Subject: Sequoyah Fuels Corporation, Docket – 40-8027
Additional Information on Site Seismicity and Geomorphology
Follow-up to Telephone Conference of September 29, 2003

TECHNICAL MEMORANDUM

TO: Craig Harlin, Sequoyah Fuels Corporation
FROM: Clint Strachan, Project Manager
DATE: December 2, 2003
SUBJECT: Response to NRC comments on Sequoyah Fuels Corporation Facility Seismicity Evaluation Report

Figure 1
Magnitude versus Surface Rupture Length

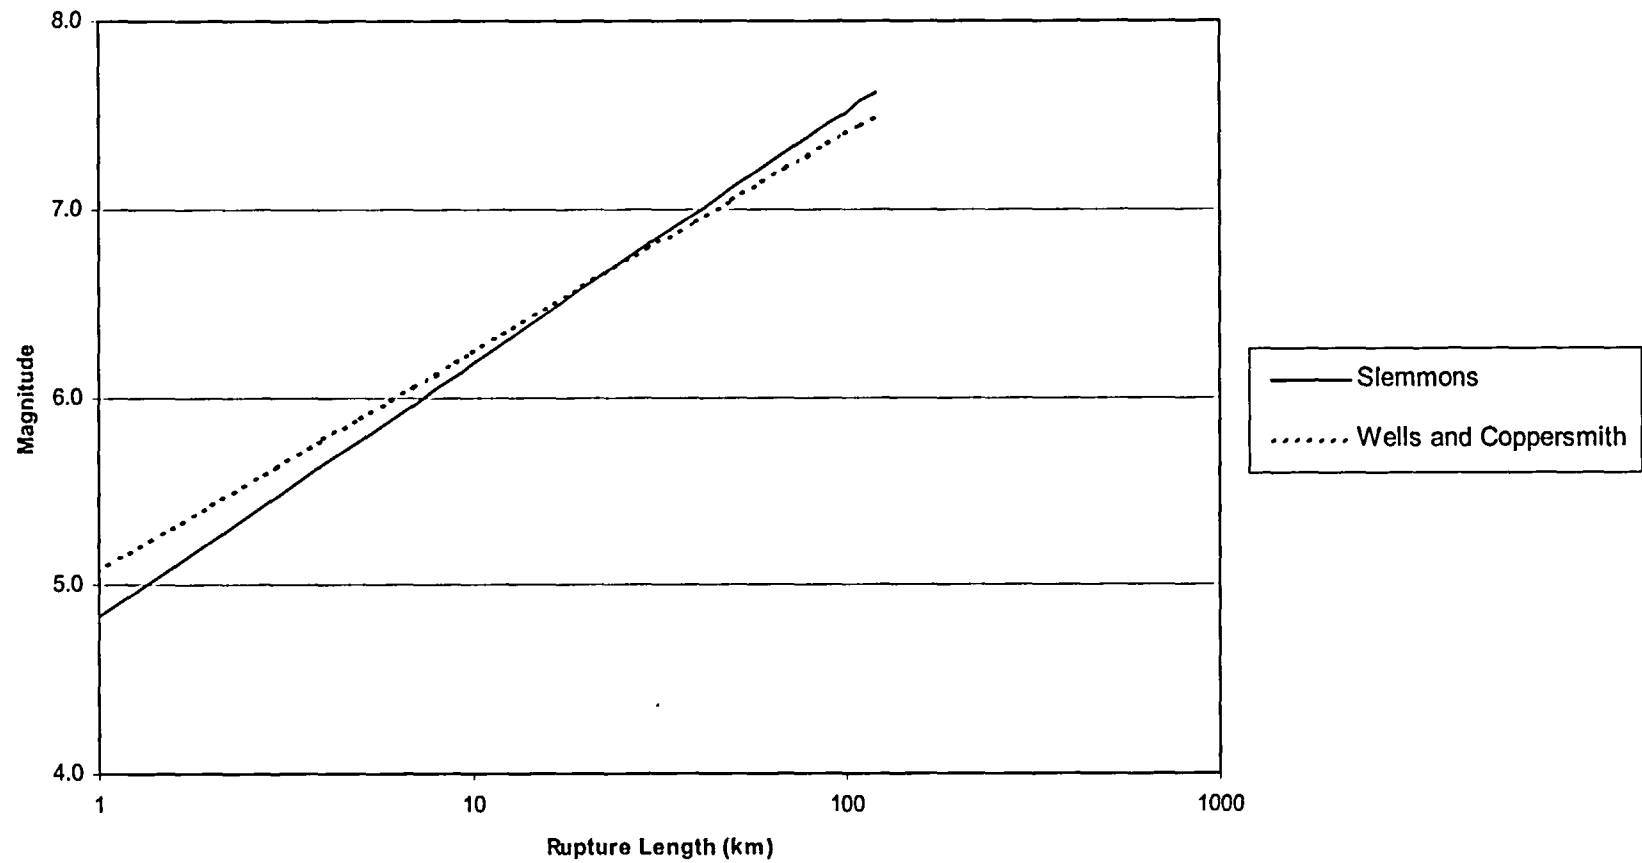
The empirical relationship between earthquake magnitude and fault surface rupture length in Section 4.3.1 (page 20) was obtained from Slemmons (1982). Are there more recent references?

Another commonly referenced paper is entitled "New Empirical Relationships among Magnitude, Rupture Length, Rupture Width, Rupture Area, and Surface Displacement" by Wells and Coppersmith (1994). The calculated magnitudes from Slemmons (1982) were compared with calculated values from Wells and Coppersmith for rupture lengths of zero to 100 km. This comparison (shown in Figure 1) shows minimal differences in calculated earthquake magnitude, and indicates that the relationships in Slemmons (1982) are still valid.
